Report: TAB Report
Function: Test, Adjust, & Balance
Date: 10/23/2025
Completed By: National TAB

PROJECT
10-13-25 QT #0839 MABLETON, GA

Project: 10-13-25 QT #0839 MABLETON, GA

Issue Name : DIFFUSERS ARE THE WRONG TYPE
Description : The installed diffusers in the kitchen are not the specified model
Created By : National TAB **Assigned To :** National TAB - Sagar Patel
Status : Open
Priority : Medium **Asset Tag :**
Originated Date : 10/16/2025 - Ben Searles - National TAB

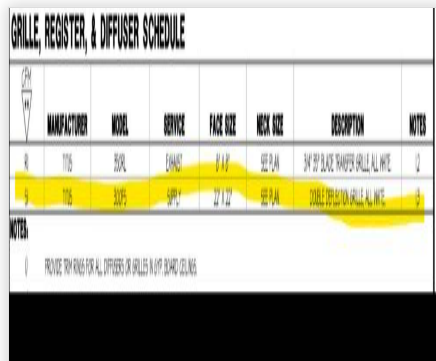
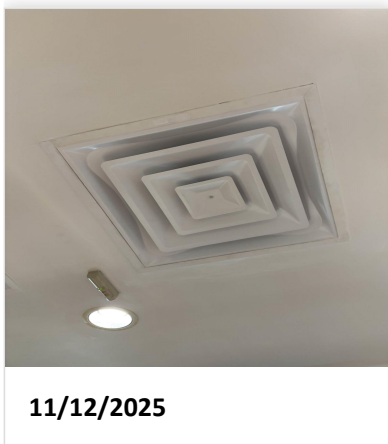
- **11/12/2025 National TAB - Sagar Patel**
 - Diffusers are still incorrect. Titus diffusers are on back order.

Asset: EF1

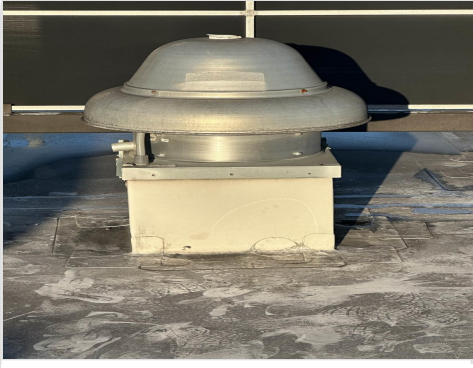
Issue Name : MISSING RETURN
Description : Return grille 1-4 is not installed. Unable to balance EF1 until the return is installed.
Created By : National TAB **Assigned To :** National TAB - Sagar Patel
Status : Open
Priority : Urgent **Asset Tag :**
Originated Date : 10/16/2025 - Ben Searles - National TAB

- **11/12/2025 National TAB - Sagar Patel**
 - Return grille is not correct and ceiling is exposed.
